CANplus RT™ Software Release Notes

Version 1.04

LOFA Document No. 463-9000-40 rev: B

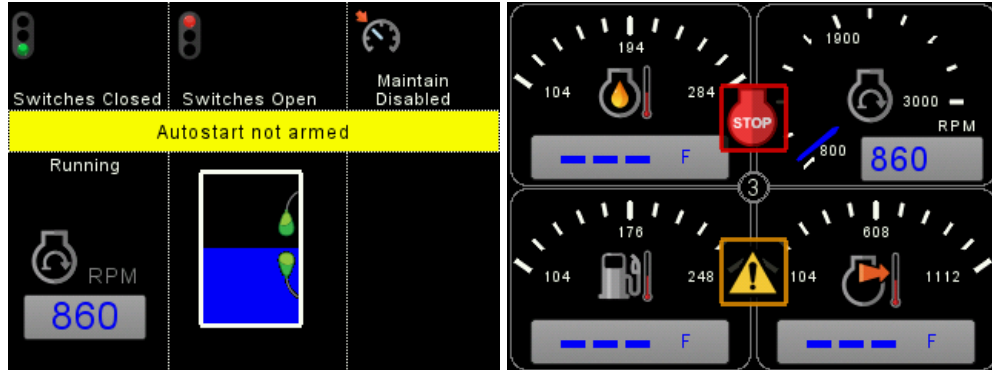
- Language
 - Italian added.
- Menu
 - Added Output Events Menu which is housing Alarm Output Menu and At Speed Menu
 - Aux inputs/outputs menu now available via display.
 - Removed "DB Viewer" from menu, now only accessible by buttonbar in gauge pages.
 - Renamed "Low side output" to "Aux Out 1"

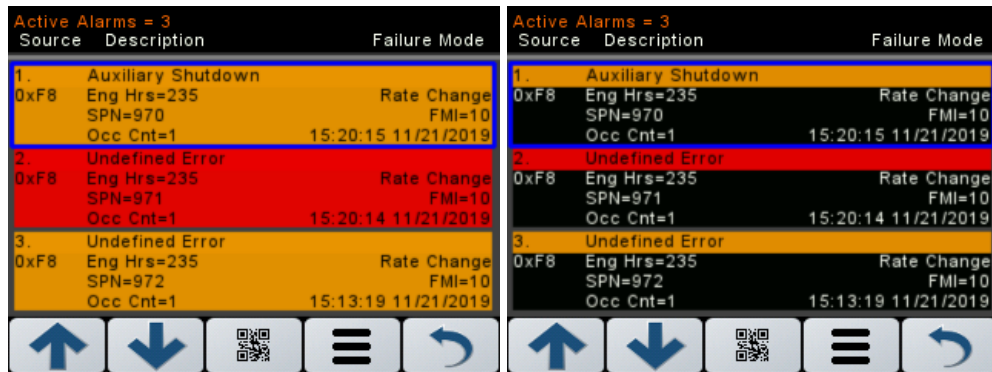
- Implemented STOP/WARNING overlay icons which indicate the active RED/AMBER status. Icons will not show up when alarm banner is present.

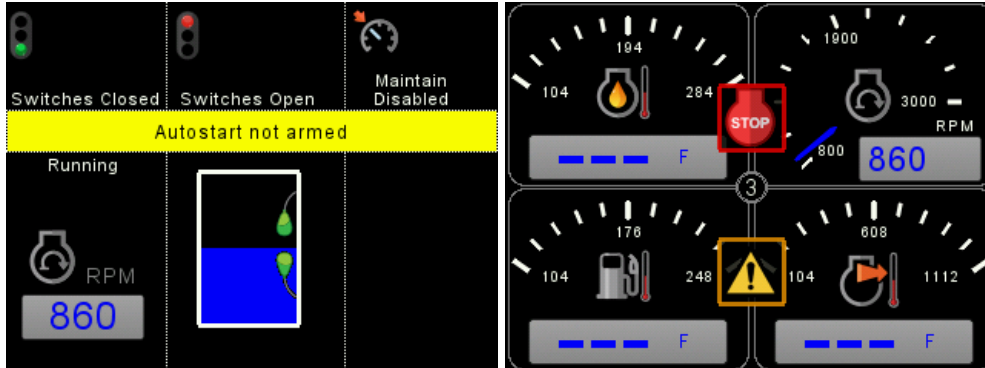
- Language
 - Italian added.
- Menu
 - Added Output Events Menu which is housing Alarm Output Menu and At Speed Menu
 - Aux inputs/outputs menu now available via display.
 - Removed "DB Viewer" from menu, now only accessible by buttonbar in gauge pages.
 - Renamed "Low side output" to "Aux Out 1"

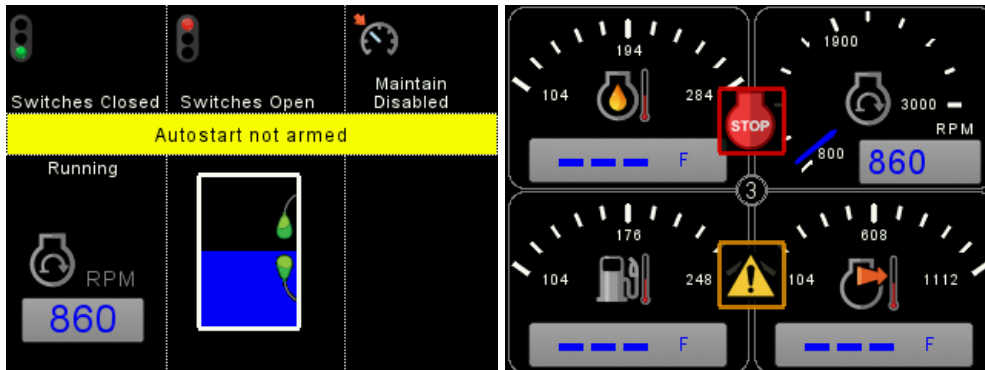
- Language
 - Italian added.
- Menu
 - Added Actuator Setup Wizard for Mechanical engines.Added Output Events Menu which is housing Alarm Output Menu and At Speed Menu
 - Aux inputs/outputs menu now available via display.
 - Removed "DB Viewer" from menu, now only accessible by buttonbar in gauge pages.

- Renamed "Low side output" to "Aux Out 1"
